# [Issue No.] FA-A-0182

**[Title]** Correction of error information on MELSEC-Q series base unit mounting dimension **[Date of Issue]** December 2014

[Relevant Models] Q65B

#### [Incorrect description]

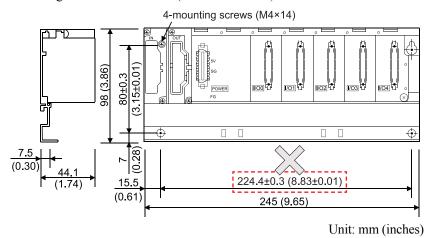
The mounting dimension of the Q65B has been corrected as shown below.

Pitch between base mounting holes: 224.4±0.3mm (8.83±0.01 inches)

Pitch between base mounting holes: 222.4±0.3mm (8.76±0.01 inches)
